Figure 1 Current lineup

Figure 2 Revised lineup

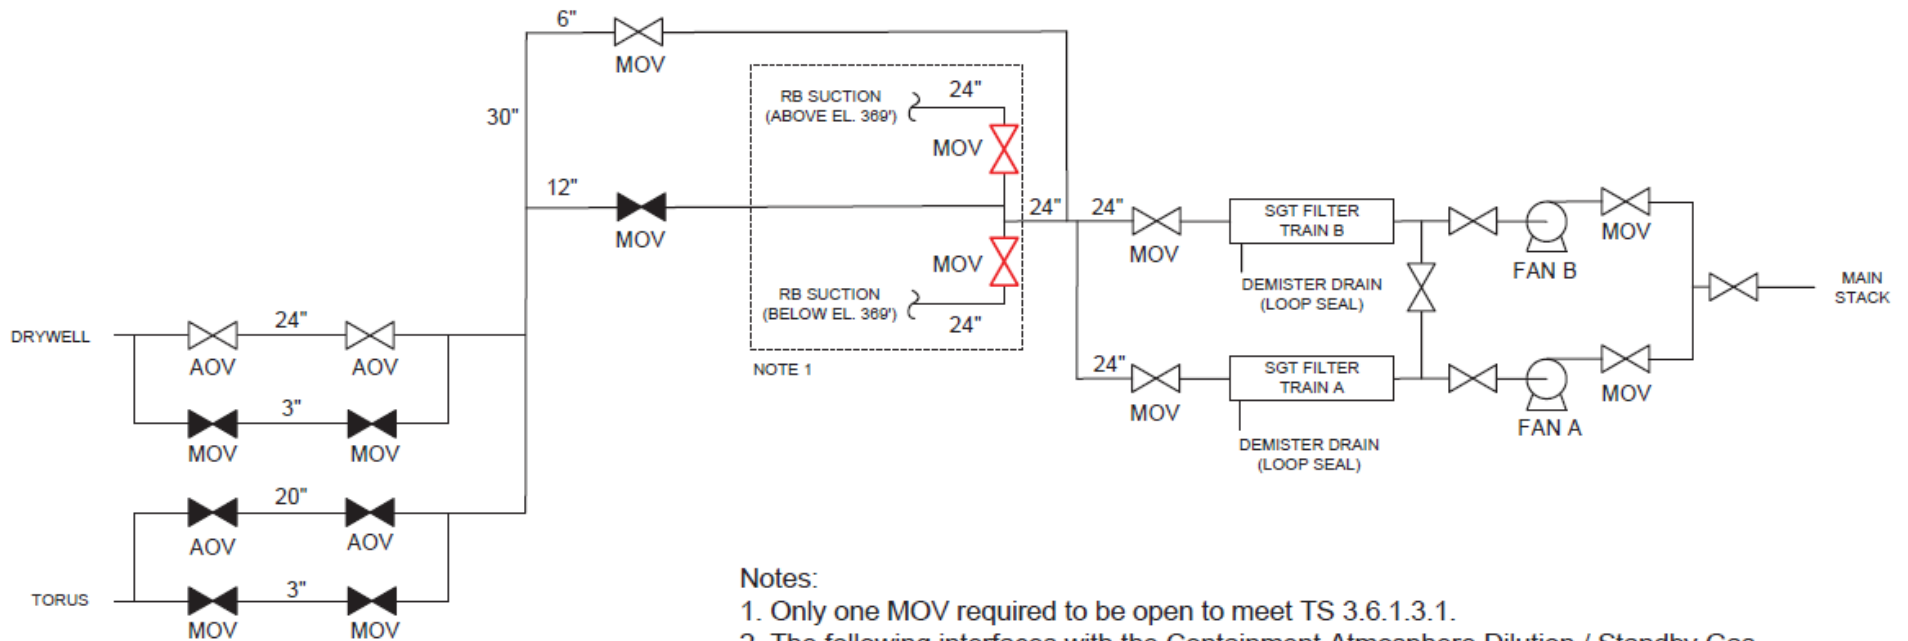
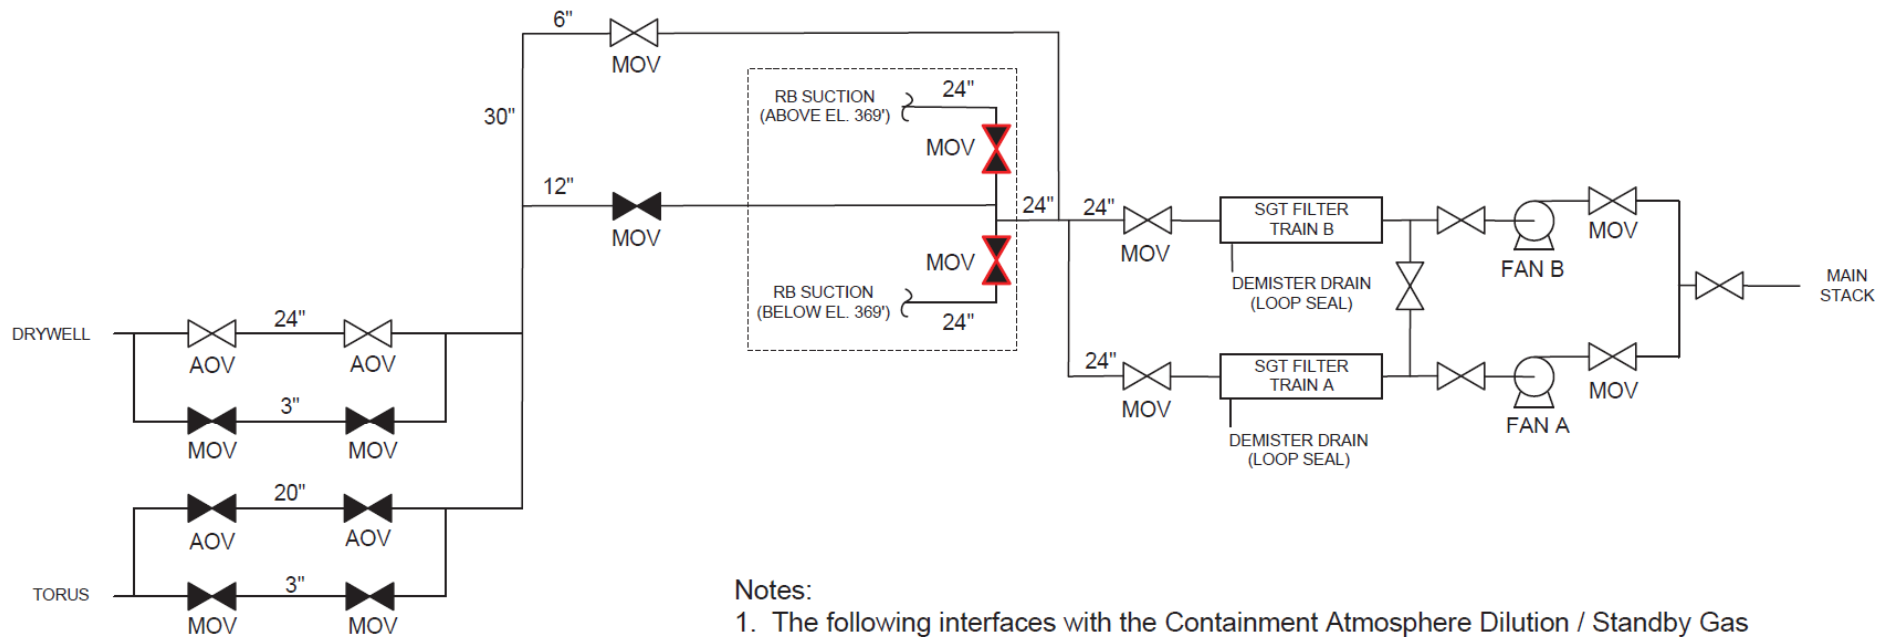
1. Only one MOV required to be open to meet TS 3.6.1.3.1.
2. The following interfaces with the Containment Atmosphere Dilution / Standby Gas Treatment Systems are not depicted but are isolated during this operation:
 - Air for Decay Heat Cooling
 - Aux Gas Treatment System
 - HPCI Gland Seal Seal Exhauster
 - Hardened Containment Vent System
 - Main Steam Leakage Collection System

1. The following interfaces with the Containment Atmosphere Dilution / Standby Gas Treatment Systems are not depicted but are isolated during this operation:

- Air for Decay Heat Cooling
- Aux Gas Treatment System
- HPCI Gland Seal Seal Exhauster
- Hardened Containment Vent System
- Main Steam Leakage Collection System
